Service Bulletin #A-102

B-Series Heaters 42D36 Switch Series -Technical Portions are FAA Approved-

JANITROL B-SERIES AIRCRAFT HEATERS - 42D36 COMBUSTION AIR PRESSURE SWITCH

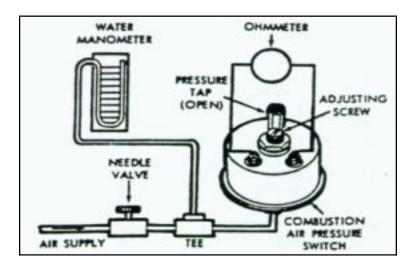
- 2.1 Locate the C/A Switch on your Heater and disconnect sense lines to isolate unit as installed in aircraft or remove unit from Heater for bench test as is most practical for your given installation.
- 2.2 Connect an adjustable air pressure line that can be controlled in a range of zero to 5 inches of water pressure and a water manometer to the high pressure port of the C/A Switch as shown in Figure 1 of this Bulletin. NOTE: the switch must be tested at 45° position from verticle (Figure 2) or as mounted in the aircraft. The manometer used must be graduated in 0.1 in. W.G. increments maximum and be zero set at the start of the test.

- 2.3 Connect an ohmmeter (analog) or continuity tester across the switch terminals to determine the exact instant of switch closing.
- Apply air pressure allowing it to build very slowly from zero and observe the reading at the instant of switch closing (continuity). The switch should close at the values shown in TABLE 1 (settings are in inches of water pressure as indicated on a water manometer). Pass or fail criteria shall be the tolerance shown in TABLE 1 (eg: 0.5 + / 0.1 shall require that the switch "make" at a maximum of 0.6 in. W.G. rising pressure and "break" at a minimum of 0.4 in W.G. falling pressure).

- 2.5 Make several trials to insure switch repeatability and reduce or lower the pressure very slowly to read accurate results. NOTE: the switch has a differential pressure tap that must be open to atmosphere during the test.

- Adjust the switch to attain repeatable readings as necessary turning the adjustment screw clockwise increases the setting and counter-clockwise decreases the setting. Apply glyptal or torque seal to screw once final setting is attained.
